Response point-by-point to Referee #1

Response point-by-point to Referee #2

The use of historical information on the regional frequency analysis of extreme skew surge

Fig. 1. Illustrative example of skew surge dataset at La Rochelle tide gauge. In black the systematic skew surge and in green the historical isolated data point (non-systematic data).

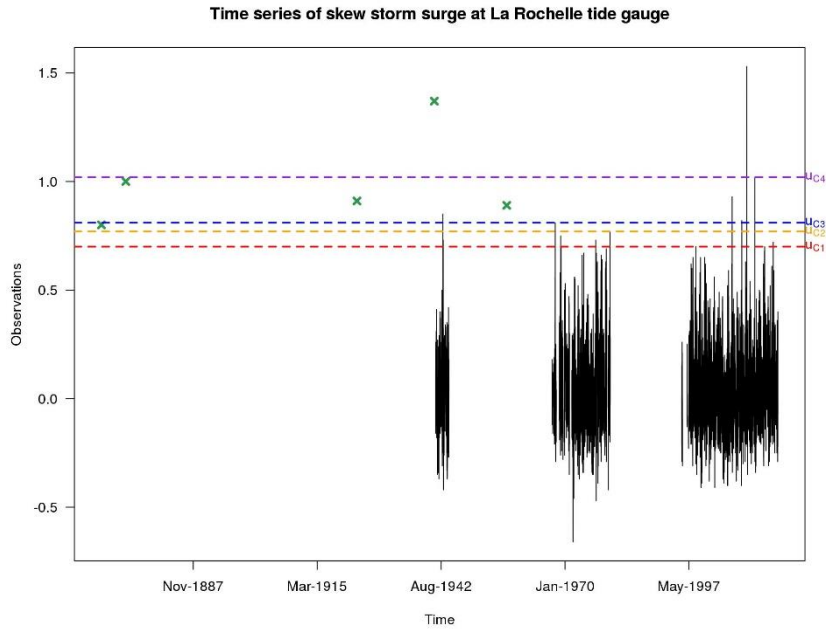
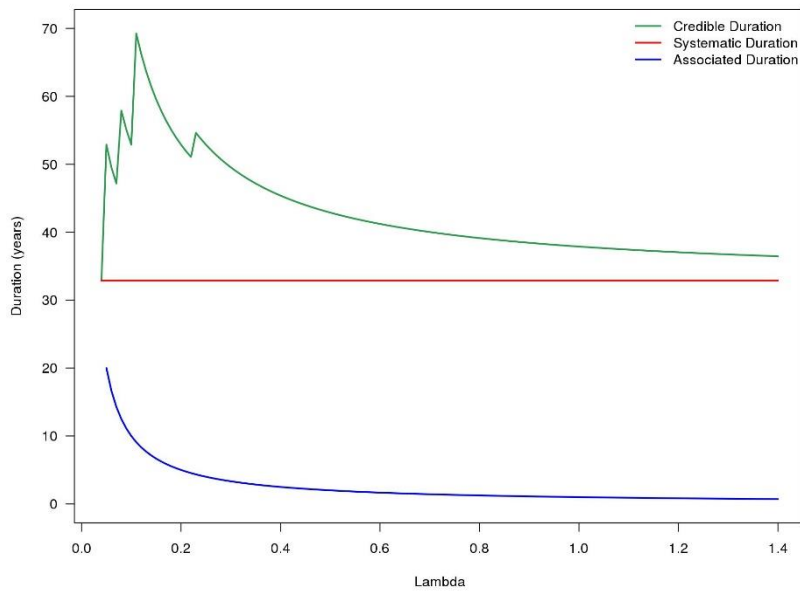
38) P6, L1, the random locations should be presented as example locations and the place names given in the figure captions.

51) Figures 1-4, where there is no data there should be no line joining the periods of data collection. This space should be left empty to indicate no data.

P8, L16-21: *“Fig. 1 shows the functional example of the whole skew surge series recorded at La Rochelle tide gauge (France). Systematic skew surges are represented by the continuous series of data plotted in black from about 1940 to 2017. They are observed during a fixed period equal to the recording time period, in this case, 32.88 years.*

The historical skew surges are artificial data generated by ourselves for this descriptive illustration and they are represented as green cross points. As they are not supposed to be obtained by continuous systematic records of skew surge measurements, the duration of their support is unknown.”

In addition the titles of the Figures 1,2 have been updated.

The Figures 1-4 have been updated and the spaces you suggest have been left empty. In addition, all the figures are resumed in only one with different thresholds.

39) P6, L12, The four cases need to be linked to a table and the figures.

14) figures 1-4: I would summerize these figures (that are almost identical) in a unique figure, trying also to explain better why they are interesting.

A link of the figures 1 and 2 of the table 1 has been added in the sentence (**P8 L29-30** of the new paper version).

The figures are summerized in a unique graph (Figure 2) where all the different thresholds are represented by different colours. The motivation of why these thresholds are interesting is expressed during all the **new Section 3** and, in particular:

P8, L29-31: *"Four cases of different values of high sampling threshold are examined (Fig.2 and Tab.1). These particular cases are chosen in order to let us know the effects of different sampling thresholds on the computation of the credible duration."*

Fig. 5. The five physically and statistically homogeneous regions for the 71 tide gauges.

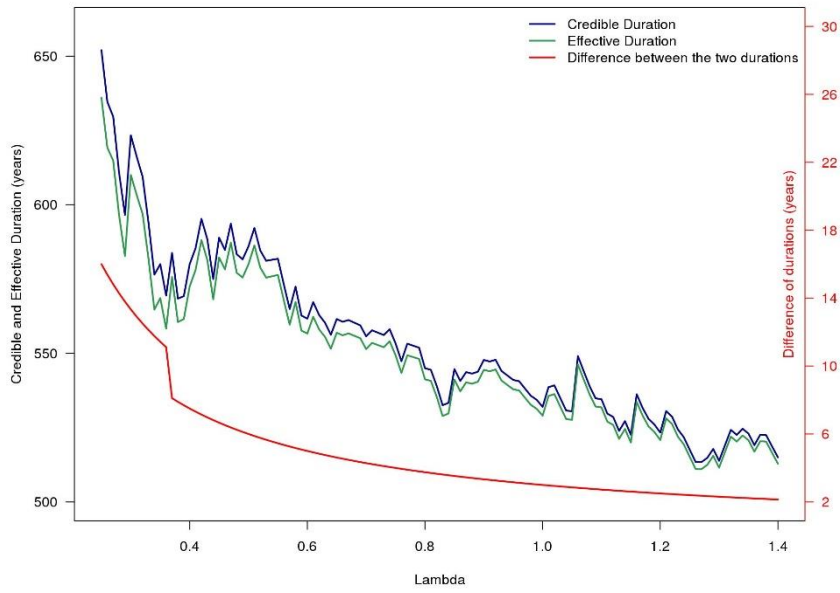
31) P4, L26, introduce Fig 7 at this point so the reader knows the region that is being considered.

The Fig.5 (the old Fig.7) has been introduced at the end of the sentence in brackets (**P5 L24** of the new paper version).
